HX-0815B

NAME	RM-8 CAP	MATERIAL	PM-9820	SCALE	1:1	ANGLE	±1°
DRAWING NO.	HX-0815B	PIN MATERIAL		UNIT	m/m	REV.	01
 <p>东莞市华欣塑胶制品有限公司 DONGGUAN HUAXIN PLASTIC MANUFACTURING PRODUCTS CO., LTD. TEL: 0769-86388088 86388188 86388288 FAX: 0769-86388111 http://www.hxbobbin.com E-Mail: hxbobbin@vip.163.com</p>	TOLERANCE OF PIN DIA ±0.05						
	PIN TENSION LOAD kg MIN				UL REC. :94V0		
	TOLERANCE: 0<L<4: ±0.1 4<L<16: ±0.2 16<L<63: ±0.3						
DRAWN & DRAFTED BY	LIN HUA JING	CHECKED & APPROVED BY		DATE:	JAN 12 2012

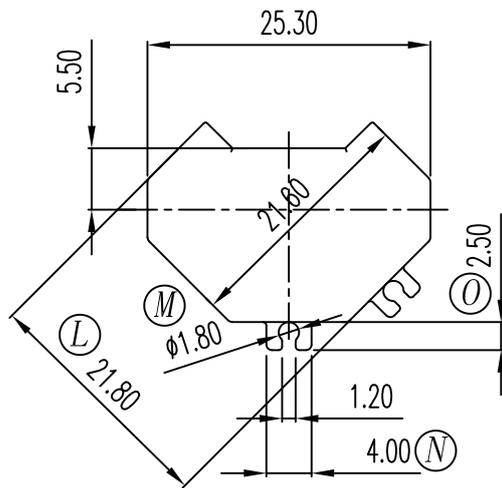
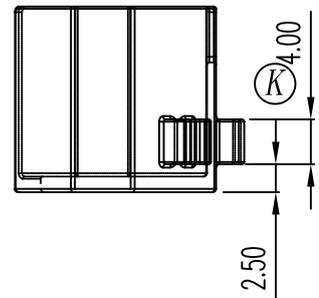
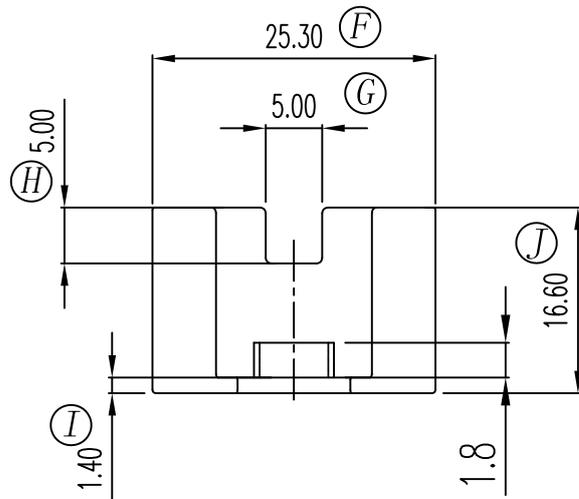
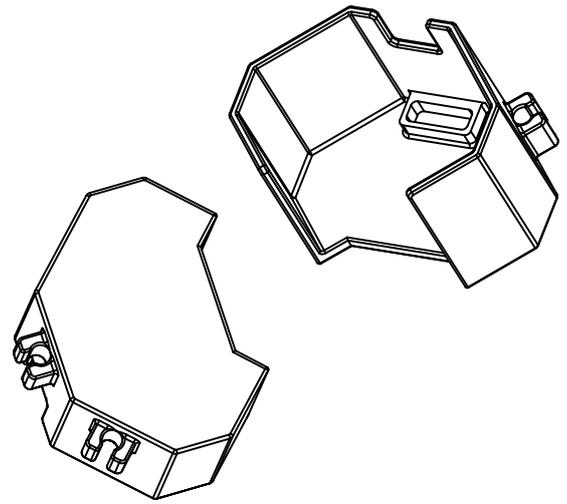
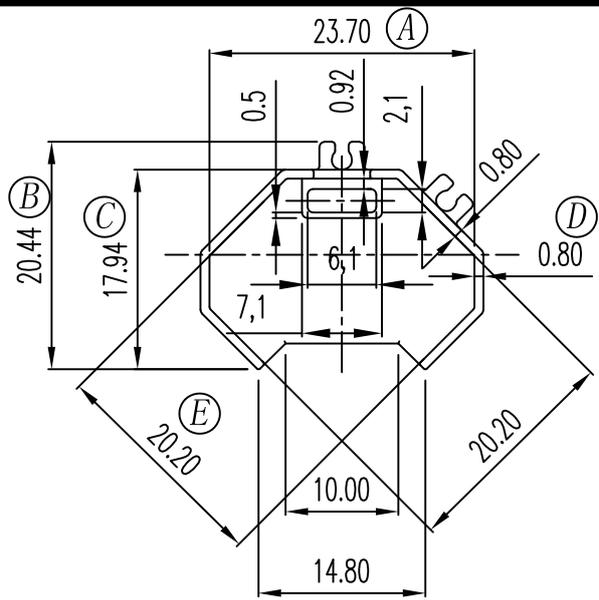
REV.	REVISION RECORD	DATE	REV	REVISION RECORD	DATE
01	1. 底部壁厚T尺寸由0.90改為1.40, J尺寸由16.10改為16.60	2013/06/10	03		
02			04
